JABIRU AIRCRAFT PTY LTD

SERVICE BULLETIN: JSB 030-2

Subject: J2XX LSA Category Weight Limitations – South Africa

Table 1 - Decals

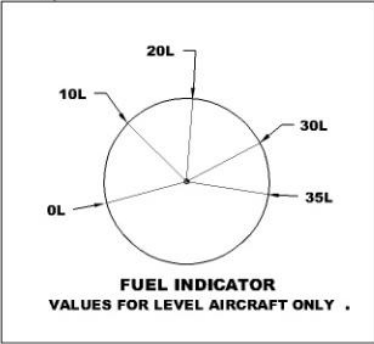
- Remove the existing baggage, fuel calibration and fuel capacity decals from the aircraft and replace them as follows:

Details	Decal
Baggage P/No. 5A123A0D

Details	Decal				
<p>Baggage P/No. 5A074A0D</p>	<p>Fit to right side fuselage wall immediately below window.</p> <div data-bbox="592 383 1300 631" style="border: 1px solid black; padding: 10px; text-align: center;"> <p><u>BAGGAGE</u></p> <p>LOAD BEHIND SEATS ONLY DO NOT LOAD AFT OF THIS POINT</p>  <p>REFER TO WEIGHT & BALANCE SECTION OF PILOT OPERATING HANDBOOK TO DETERMINE AIRCRAFT TRIM.</p> </div> <p>Fit to inside of fuselage on right side just below rear quarter window. Locate vertical line in line with rear of baggage shelf.</p>				
<p>Baggage Zones P/No. 5A063A0D</p>	<div data-bbox="619 761 1278 1070" style="border: 1px solid black; padding: 10px;"> <table style="width: 100%; border-collapse: collapse;"> <tr> <td style="width: 50%; border-right: 1px solid black; padding: 5px;"> <p>BAGGAGE ZONE A AFT LIMIT</p> <p>FORWARD LIMIT AT MAIN UNDERCARRIAGE.</p> </td> <td style="width: 50%; padding: 5px;"> <p>BAGGAGE ZONE B FORWARD LIMIT</p> <p>AFT LIMIT AT BOTTOM OF REAR BULKHEAD.</p> </td> </tr> <tr> <td colspan="2" style="text-align: center; padding: 5px;"> <p>SEE FLIGHT MANUAL SECTION 6 FOR DETAILS</p> </td> </tr> </table> </div> <p>Fitted on inside of fuselage on RHS of cabin. Locate line 500mm aft of seat backs.</p>	<p>BAGGAGE ZONE A AFT LIMIT</p> <p>FORWARD LIMIT AT MAIN UNDERCARRIAGE.</p>	<p>BAGGAGE ZONE B FORWARD LIMIT</p> <p>AFT LIMIT AT BOTTOM OF REAR BULKHEAD.</p>	<p>SEE FLIGHT MANUAL SECTION 6 FOR DETAILS</p>	
<p>BAGGAGE ZONE A AFT LIMIT</p> <p>FORWARD LIMIT AT MAIN UNDERCARRIAGE.</p>	<p>BAGGAGE ZONE B FORWARD LIMIT</p> <p>AFT LIMIT AT BOTTOM OF REAR BULKHEAD.</p>				
<p>SEE FLIGHT MANUAL SECTION 6 FOR DETAILS</p>					
<p>Electric Fuel Gauge Quantities. P/No. 5A105A0D</p> <p>Where Equipped.</p>	<div data-bbox="486 1198 1396 1585" style="text-align: center;">   <p>FUEL INDICATOR VALUES FOR LEVEL AIRCRAFT ONLY .</p> </div> <p>Fit inside wing root immediately aft of windows through to electric fuel gauge senders. Fit inner decal to outer in accordance with Procedure AVDALSR040-1</p>				
<p>Fuel Grade- Wing Tanks P/No 5A124A0D</p> <p>2 OFF</p>	<div data-bbox="715 1758 1203 1975" style="border: 1px solid black; padding: 10px; text-align: center;"> <p><u>FUEL</u></p> <p>AVGAS 100LL 33 LITRE CAPACITY EARTH ON POST</p> </div> <p>Attach to top skin of wing adjacent to Fuel Filler Cap.</p>

Figure 1 – Installation Drawing

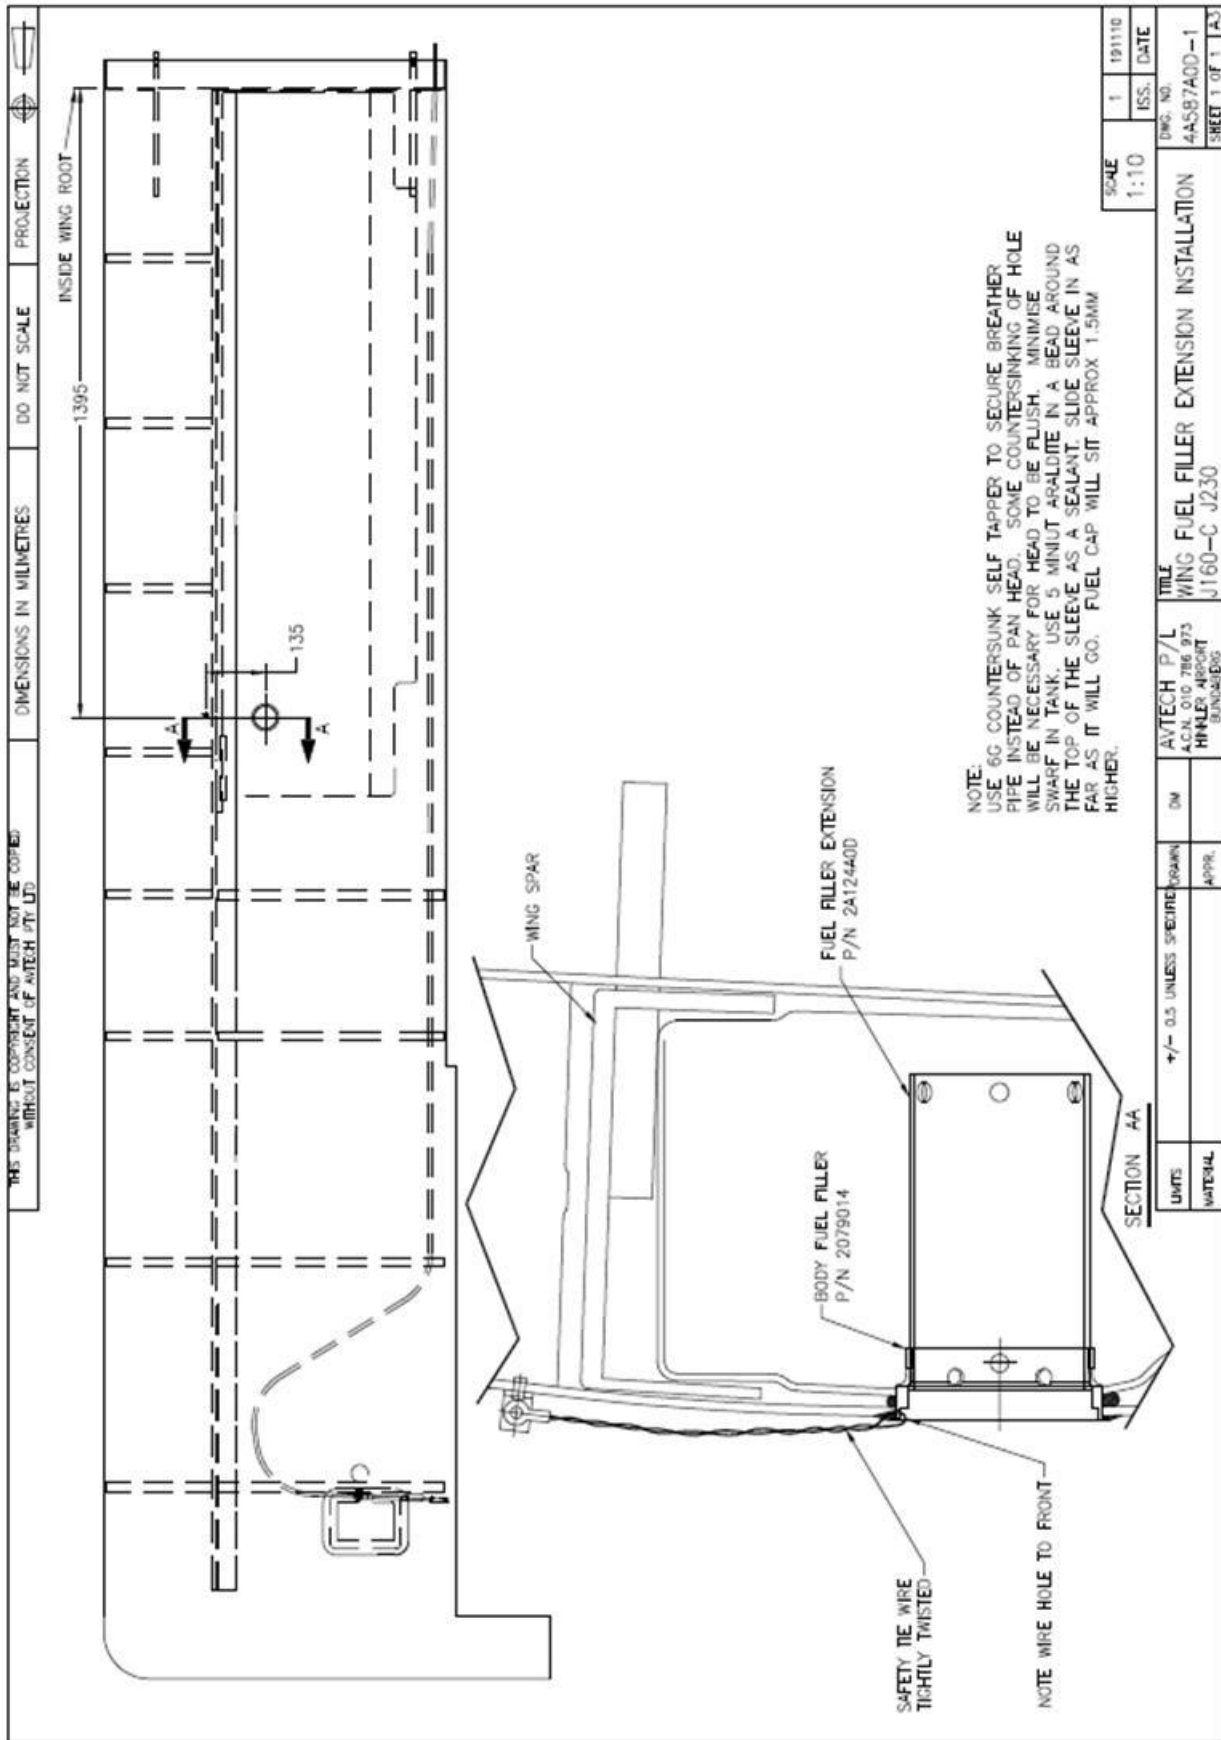
- Remove the existing Pilot's Operating Handbook and replace it with the latest approved manual revision for the model.
- Fit fuel tank filler sleeve P/No. 2A124A0D to the fillers of both wing tanks. Fit the sleeve as detailed in drawing 4A547A0D (Figure 1 below).
